VERMONT YANKEE NUCLEAR POWER CORPORATION

September 16, 1999
BVY 99-115

Subject: Vermont Yankee Nuclear Power Station
 License No. DPR-28 (Docket No. 50-271)
 Response to Request for Additional Information Regarding
Spent Fuel Pool Storage Capacity Expansion

Response to Request for Additional Information Regarding
Spent Fuel Pool Storage Capacity Expansion
(Civil and Mechanical Engineering Considerations)

Figure RAI 1.1

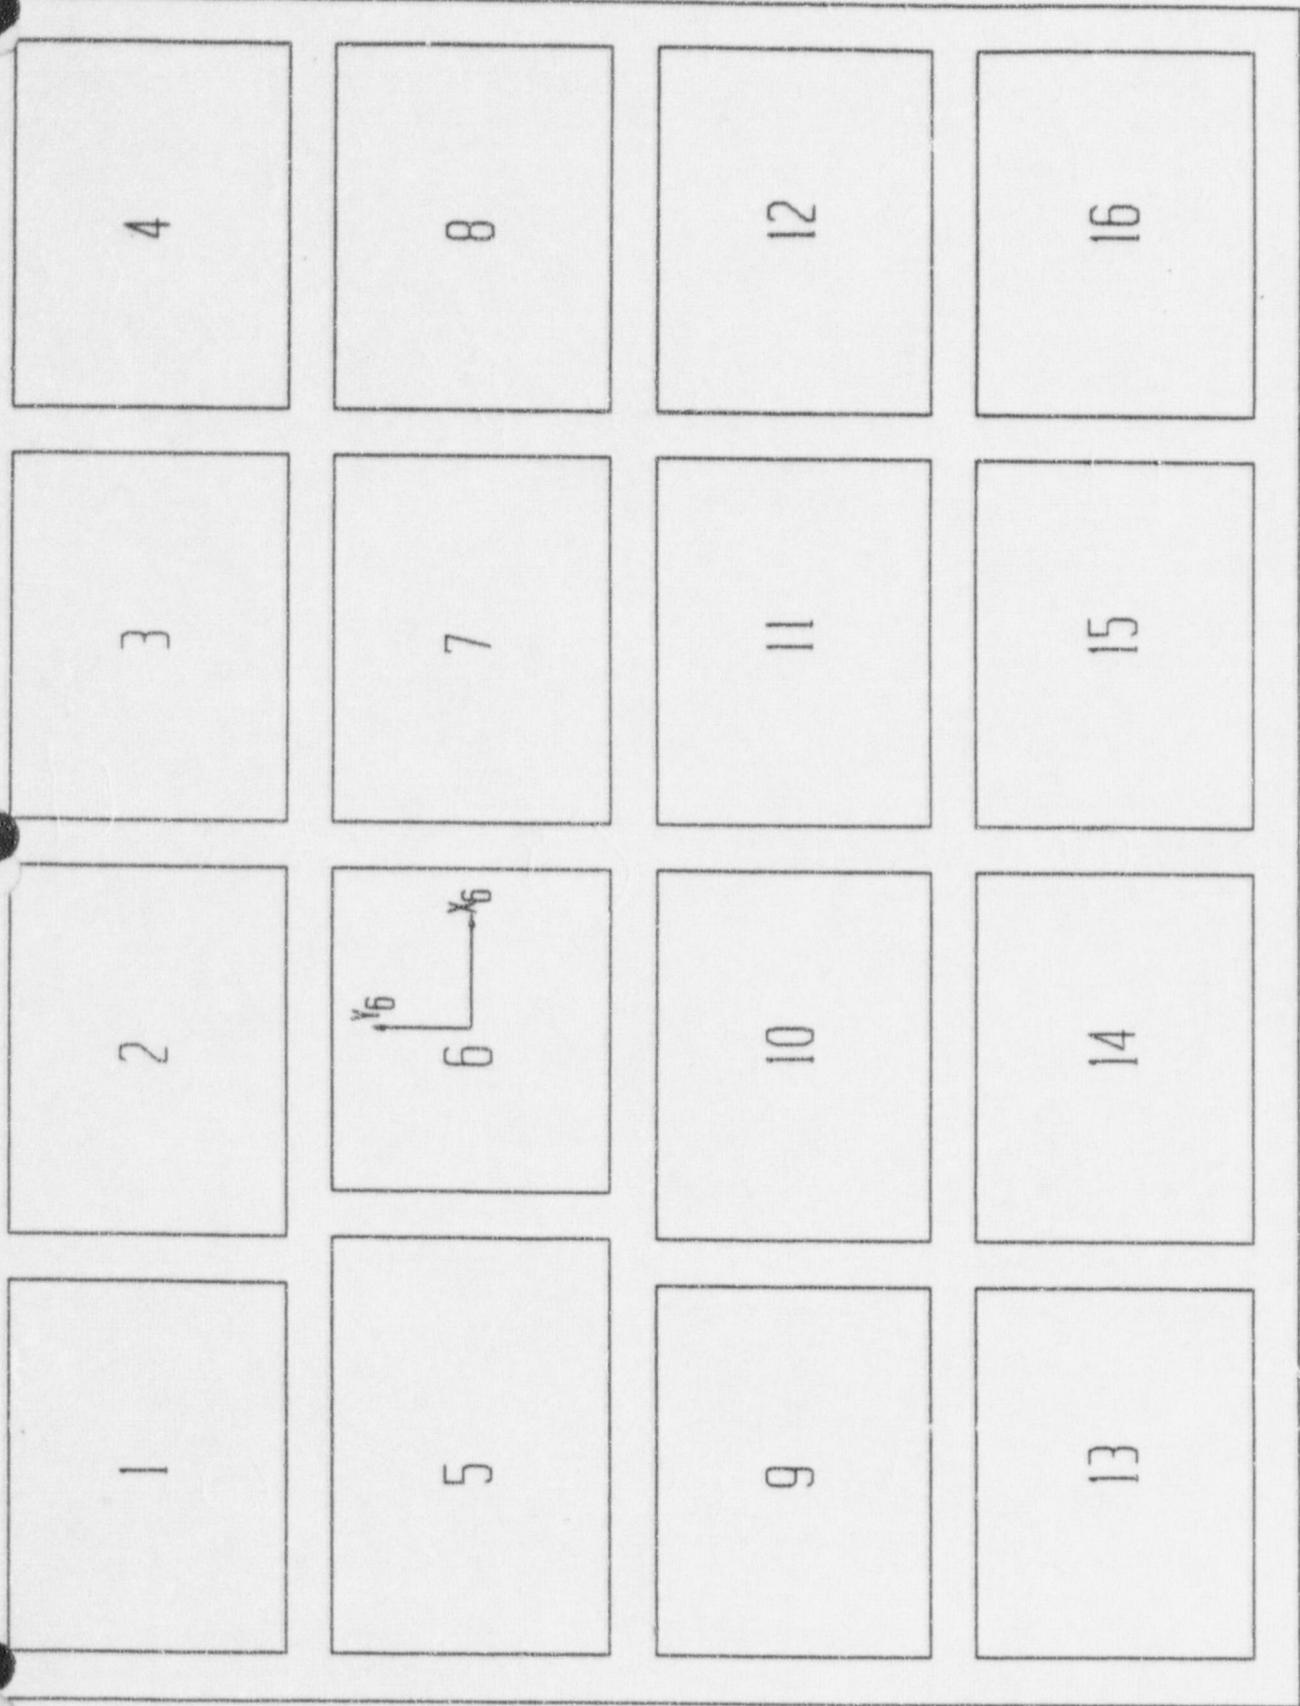
You indicated that the calculated seismic loading stresses in a fully-loaded rack will not exceed that of SRP Section 3.8.4 which was used as a guide. With respect to your stress calculations using the DYNARACK computer code presented in Chapter 6 of the submittal, provide the following:

- a) Explain how the simple stick model used in the dynamic analyses can represent accurately and realistically the actual highly-complicated nonlinear hydrodynamic fluid-rack structure interactions and behavior of the fuel assemblies and the box-type rack structures. Discuss whether or not a finite element (FE) model with 3-D plate, beam and fluid elements together with appropriate constitutive relationships would be a more realistic, accurate approach to analyze the fluid-structure interactions in contrast to the stick model.

As an example, refer to Figure RAI 1.1, where an array of N ($N = 16$) two-dimensional bodies (each with two degrees of freedom) is illustrated. The dynamic equilibrium equation for the i -th mass in the x -direction can be written as:

The problem to be investigated is shown in Figure RAI 1.1, which shows an orthogonal array of sixteen rectangles which represent a unit depth of the sixteen spent fuel racks in the Vermont Yankee Spent Fuel Pool. The rectangles are surrounded by narrow fluid filled channels whose width is much smaller than the characteristic length or width of any of the racks. The spent fuel pool walls are shown enclosing the entire array of racks.

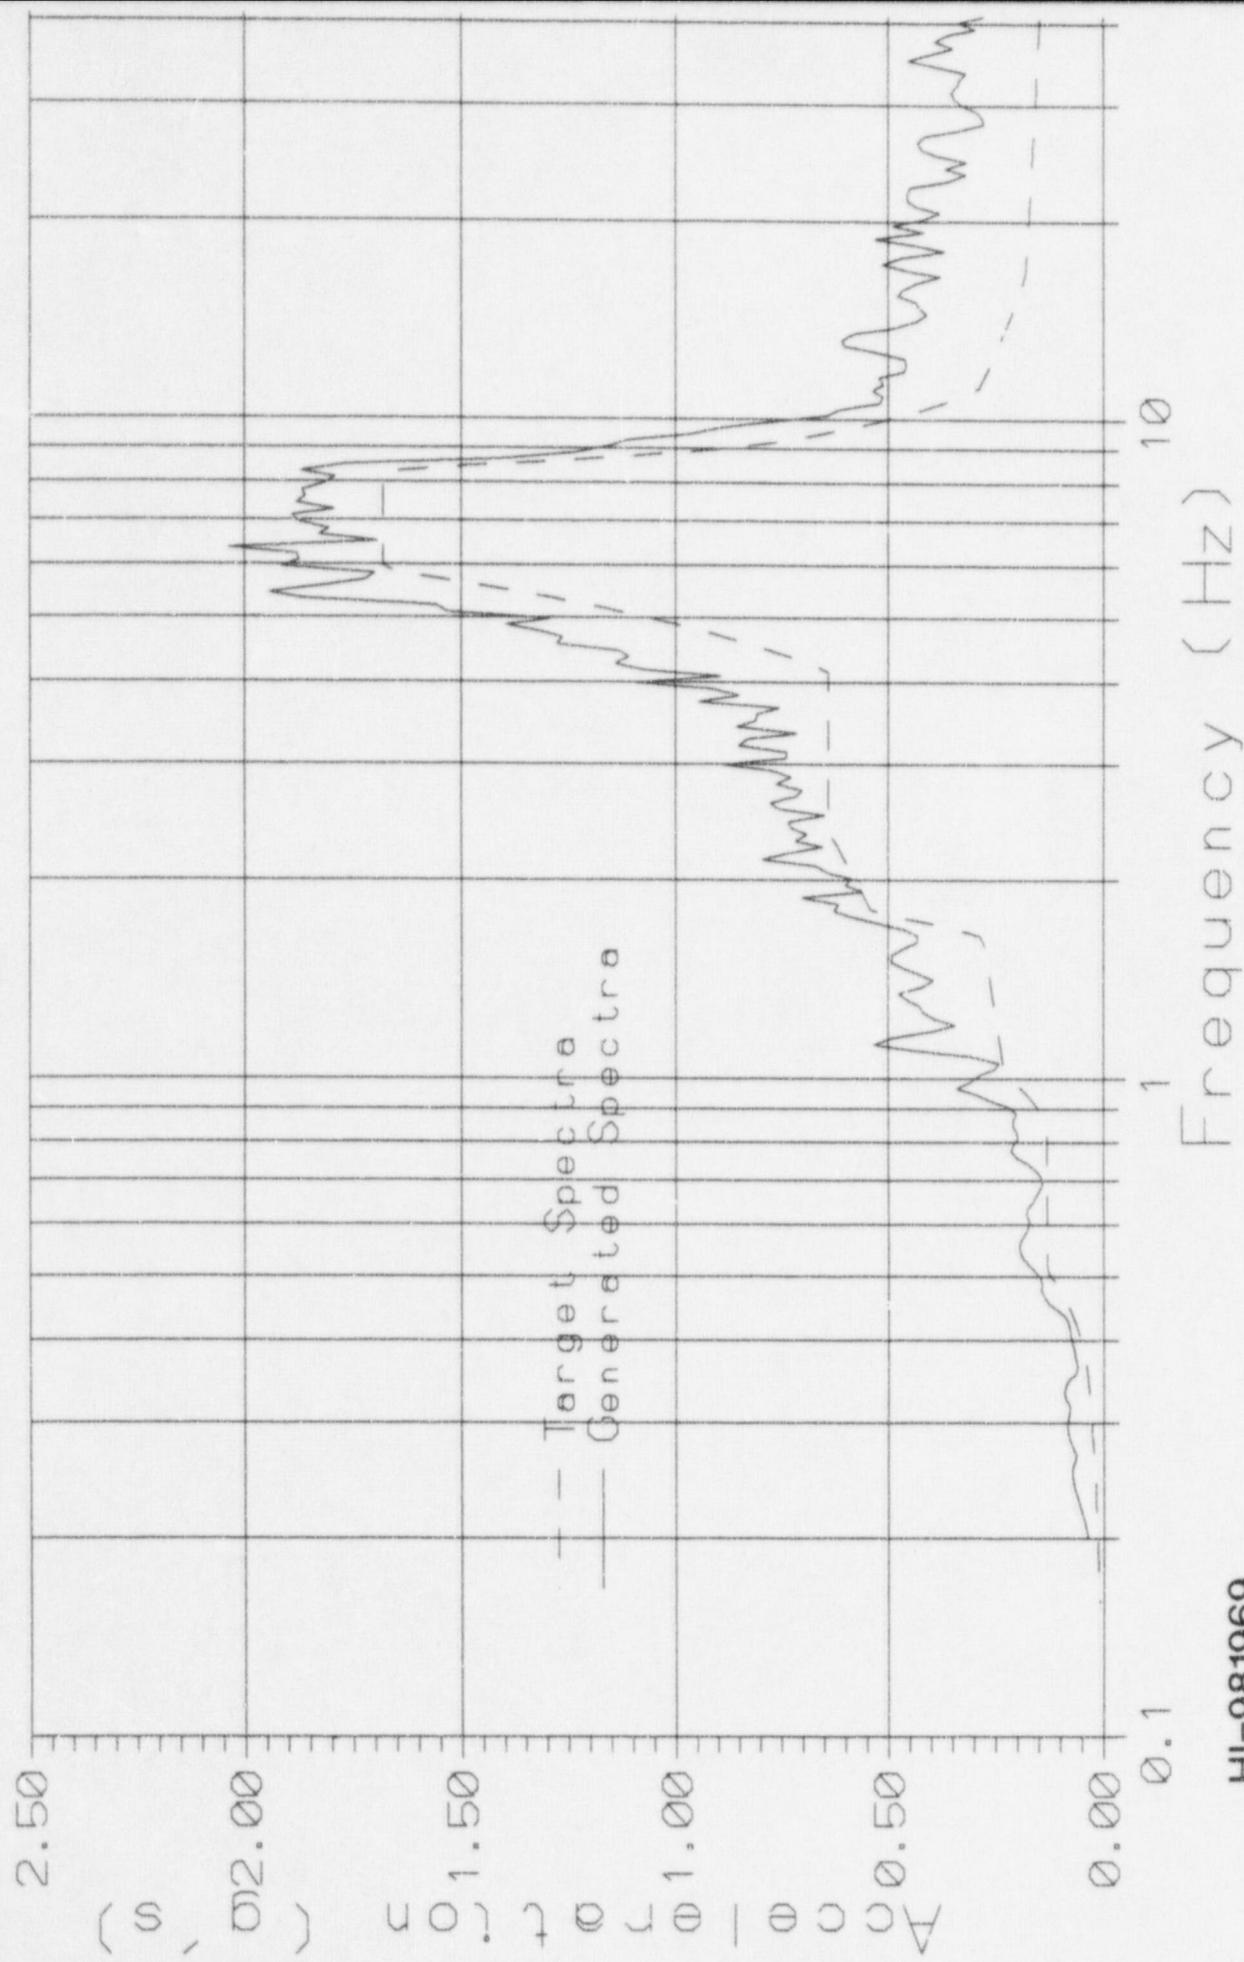
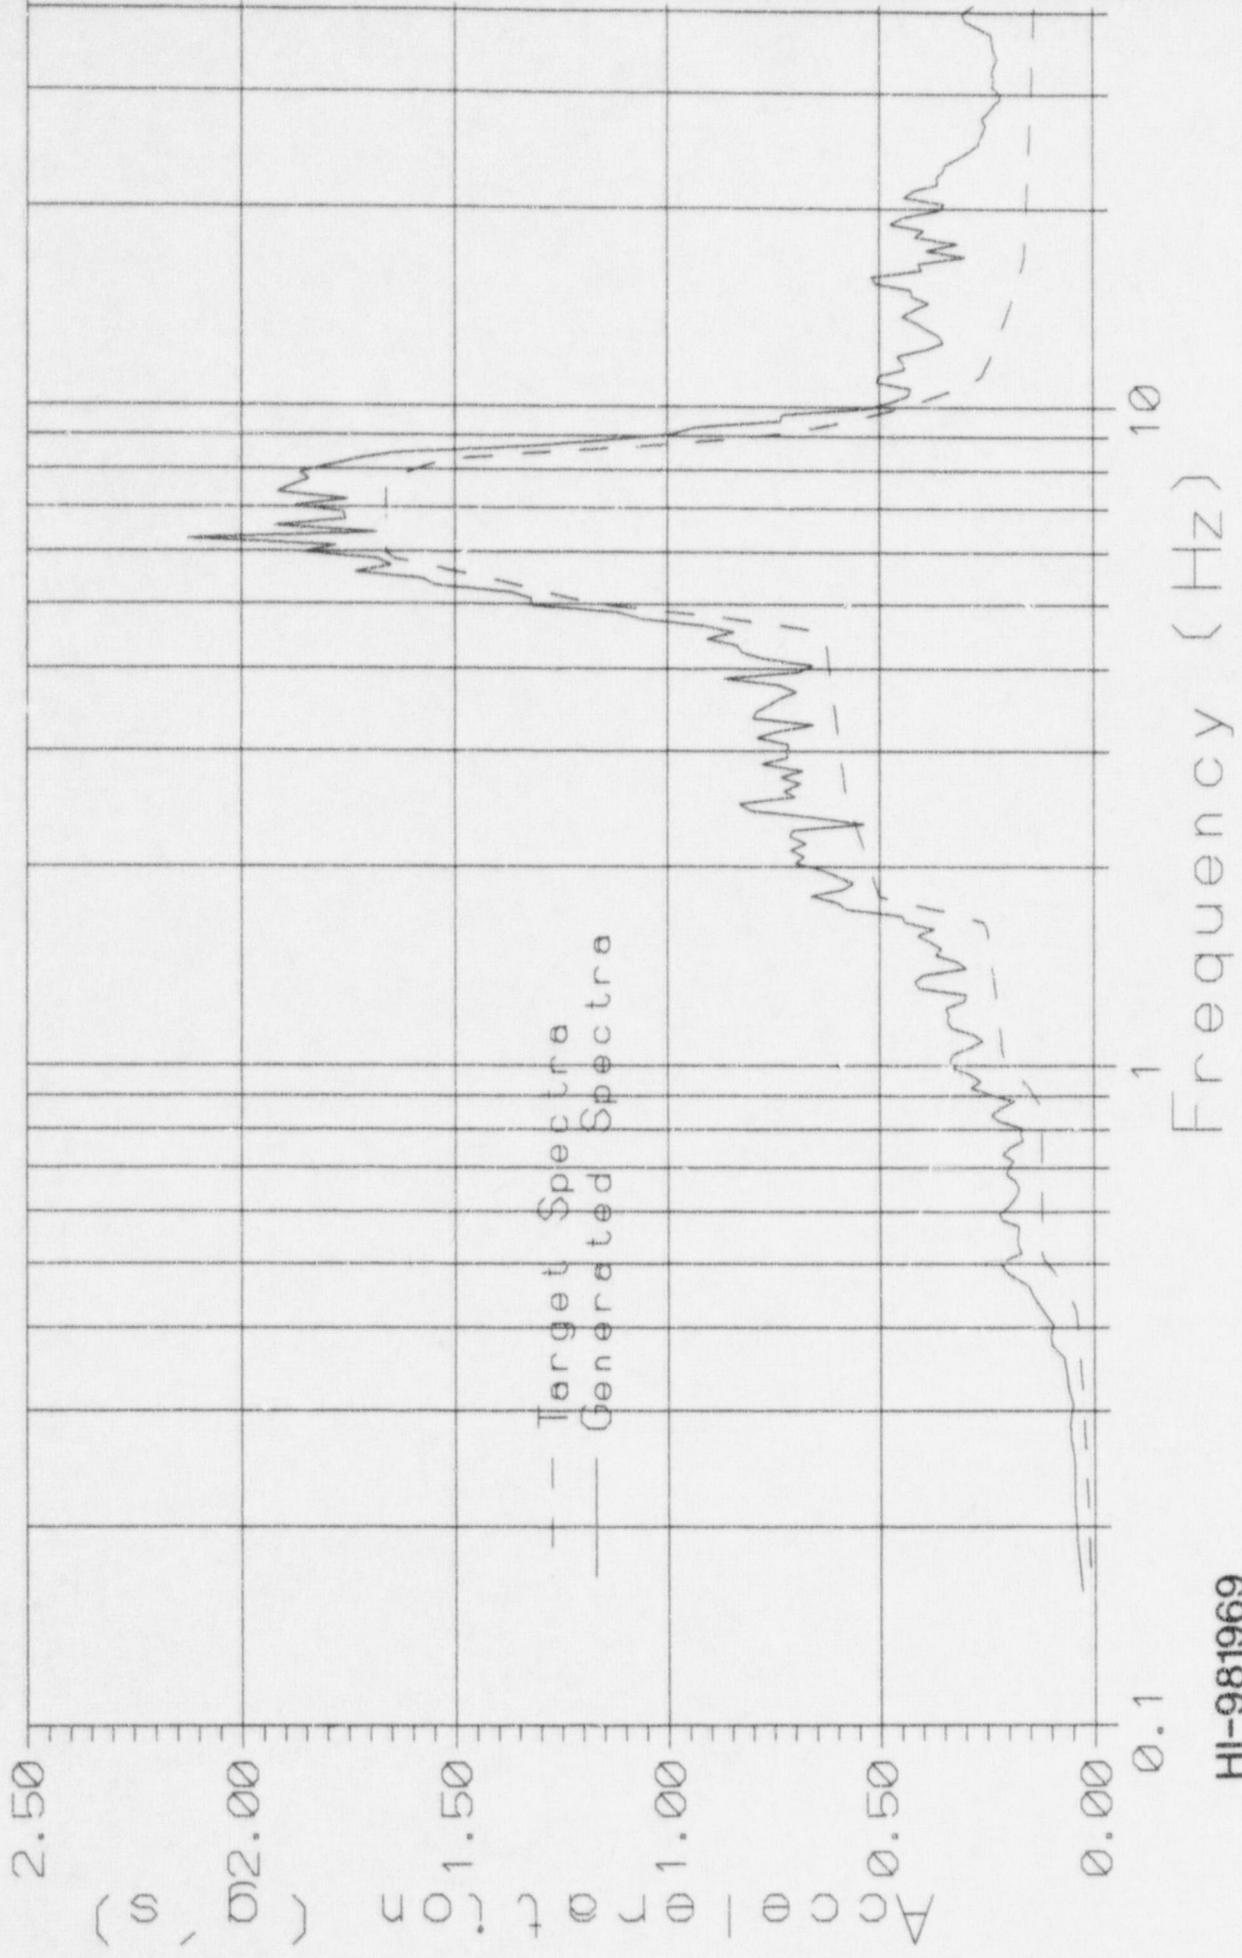
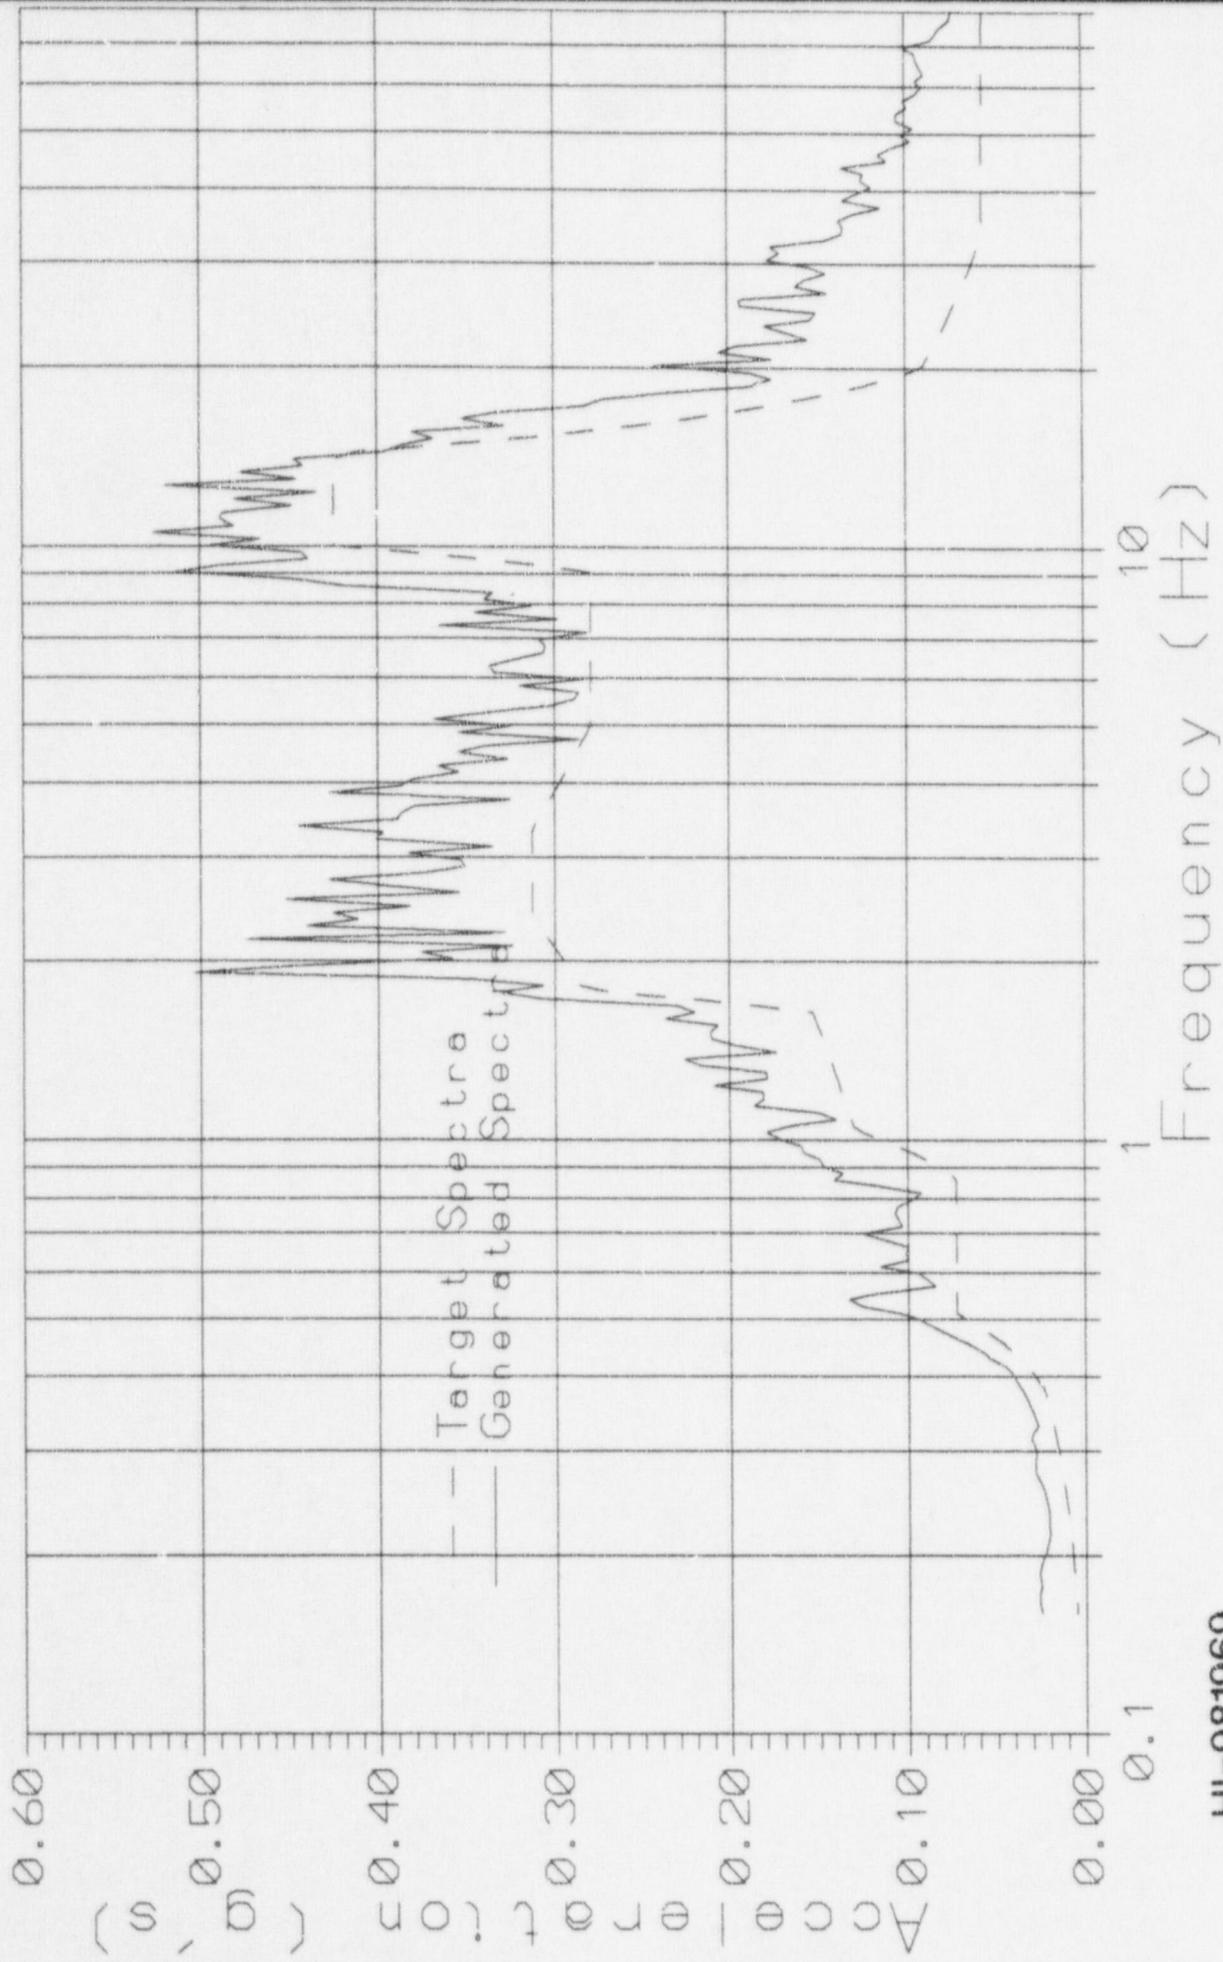
- e) Demonstrate that the artificial seismic time histories used in the analyses satisfy the power spectral density (PSD) requirement of Standard Review Plan (SRP) Section 3.7.1.

Holtec Report HI-981969 provides the details of the development of the time histories used for the Vermont Yankee pool from the design basis Response Spectra. Figures RAI 1.4-1.9, reproduced from that report, demonstrate the required enveloping of the target PSD, over the frequency range important to spent fuel racks (3-7Hz) by the PSD regenerated from the developed time histories.
